**FOIA/PA NO: 2013-0240**

**From:** Cahill, Christopher  
**Sent:** Wednesday, October 03, 2012 4:29 PM  
**To:** Ziedonis, Adam  
**Cc:** Hansell, Samuel  
**Subject:** Spent Fuel Pool HRA

**ADVISORY COMMITTEE ON REACTOR SAFEGUARDS**  
**Spent Fuel Pool Scoping Study**

Figure 4.7 Estimated Individual Risk of Permanent Relocation vs. Distance (Mean) (1/yr)

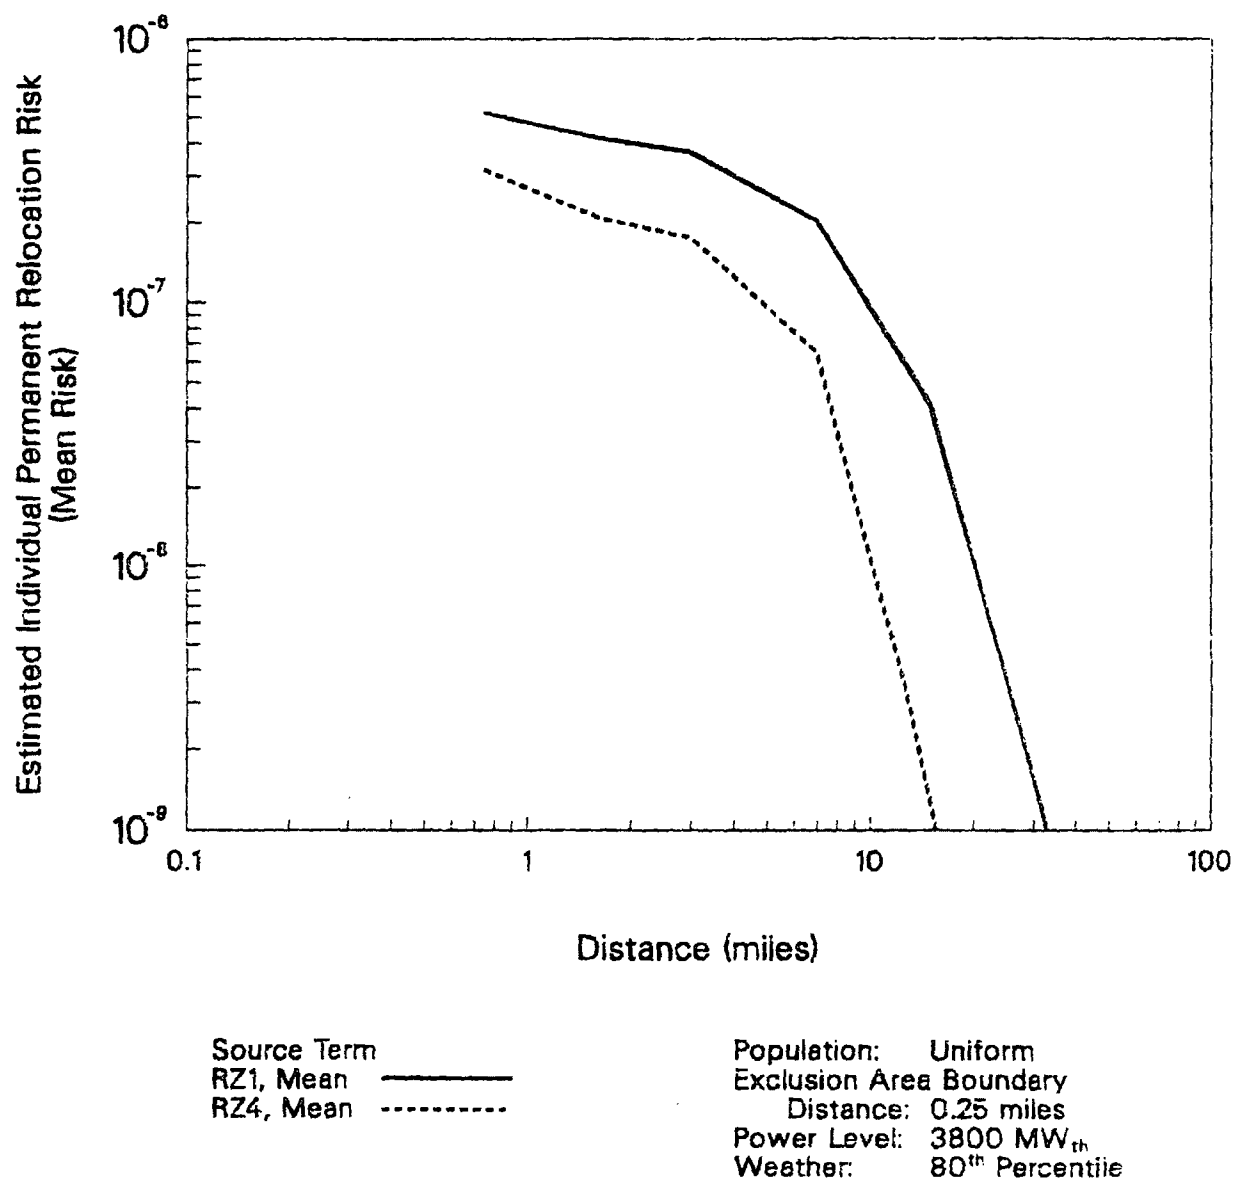
Same information, but a different way to present.

Figure 4.7 Estimated Individual Risk of Permanent Relocation vs. Distance (Mean) (1/yr)

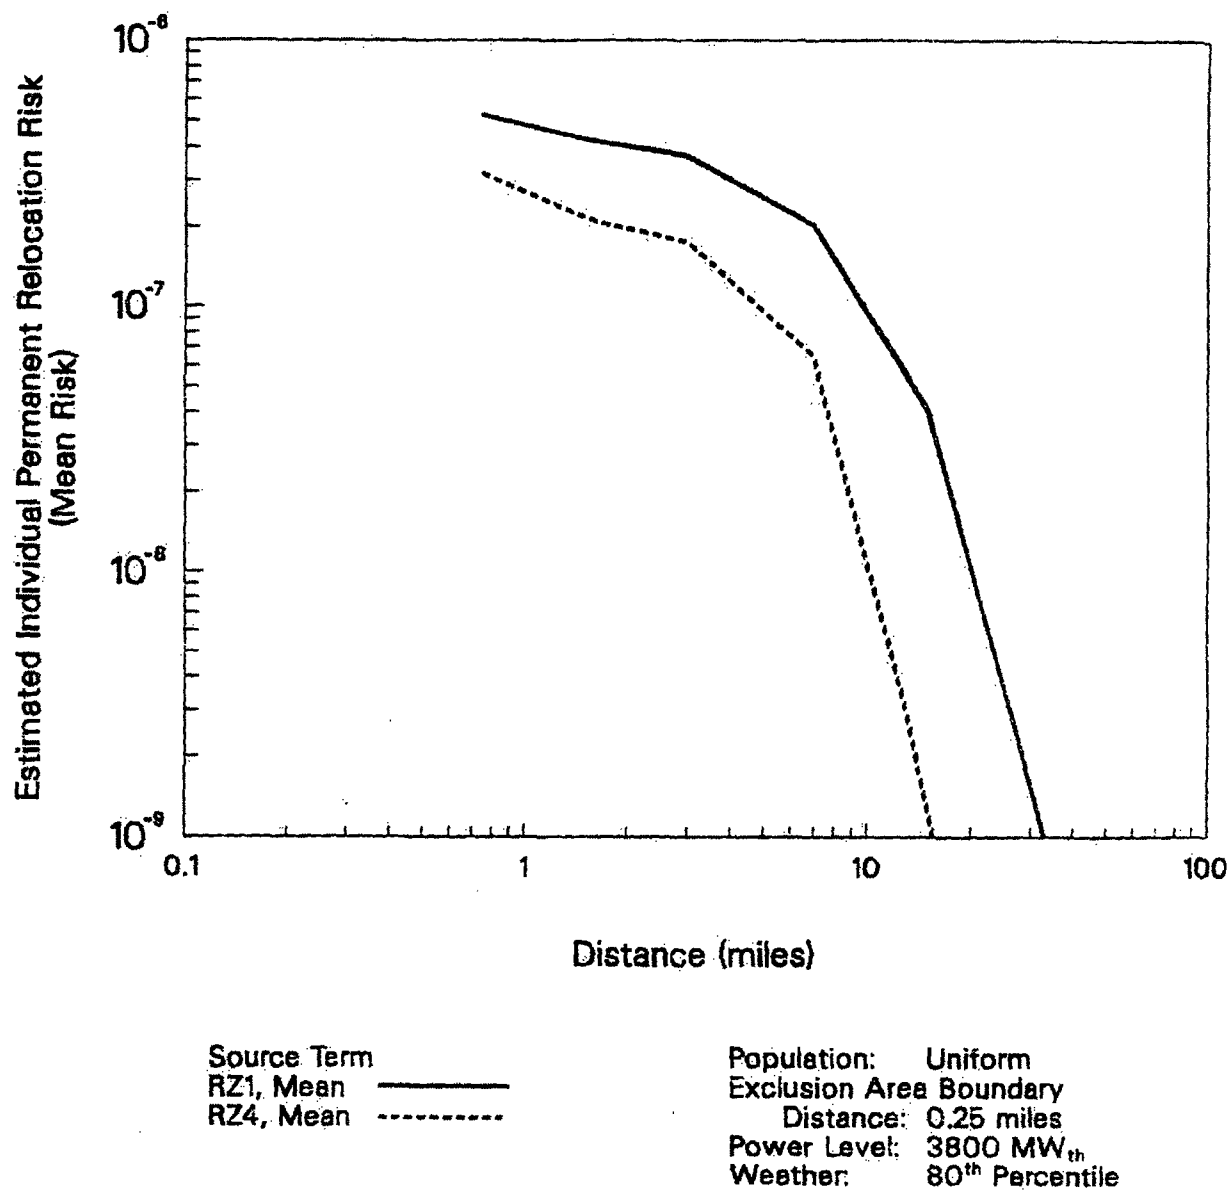
Same information, but a different way to present.
